Subject: Submittal of Revisions to the Quality Assurance Plan for Shipping Program

Description of Changes – Quality Assurance Program, Revision 23

# Quality Assurance Plan For Shipping Program

September 2017  
Rev. 23

Figure 1.1.1

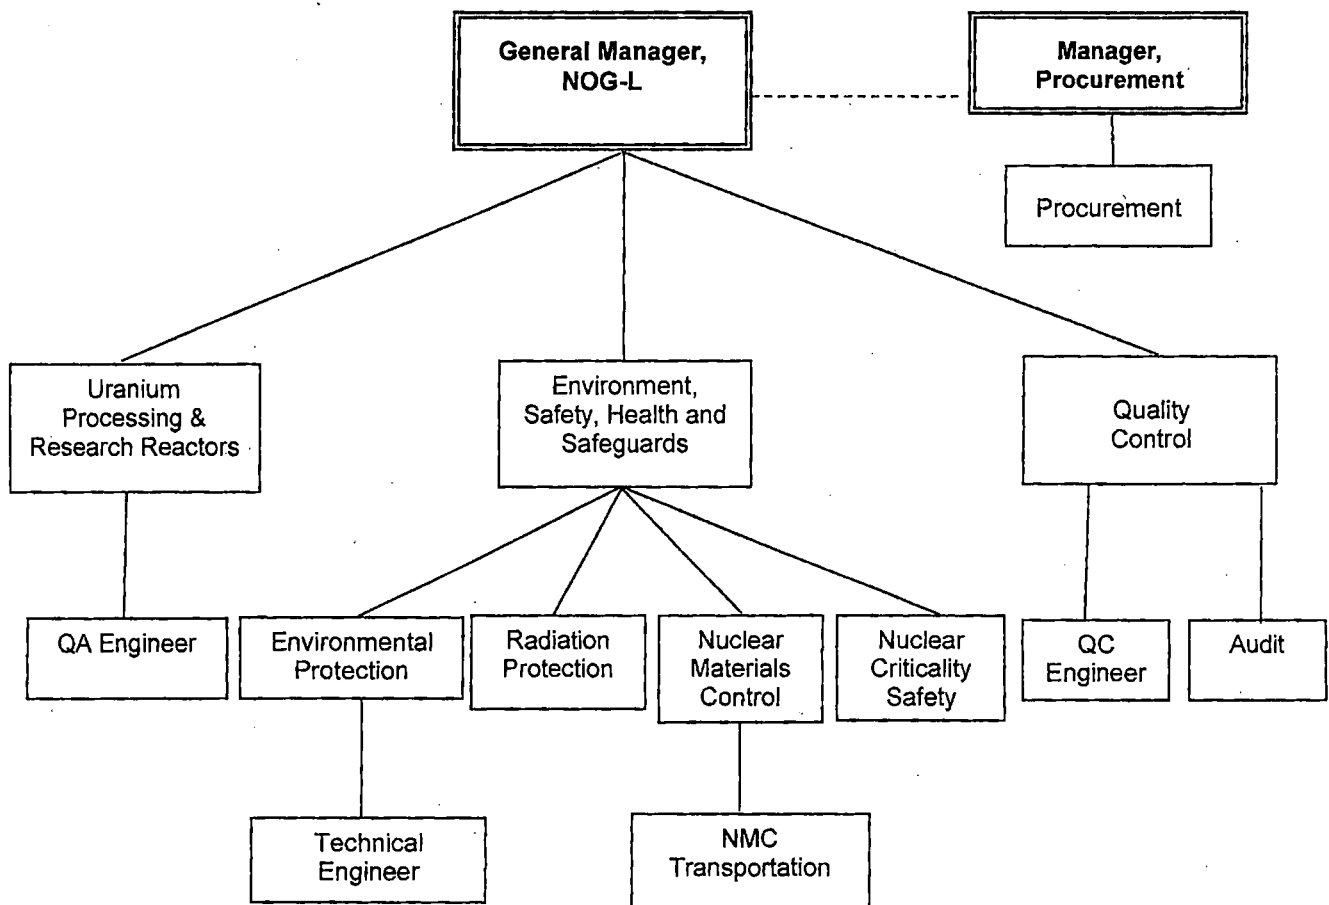
Section	Description of Change
Entire Document	Changed "Accountability Operations" to "Transportation".
Entire Document	Changed "Approved Supplier List" to "Composite Supplier List".
Figure 1.1.1	Added Audit group to the Figure.
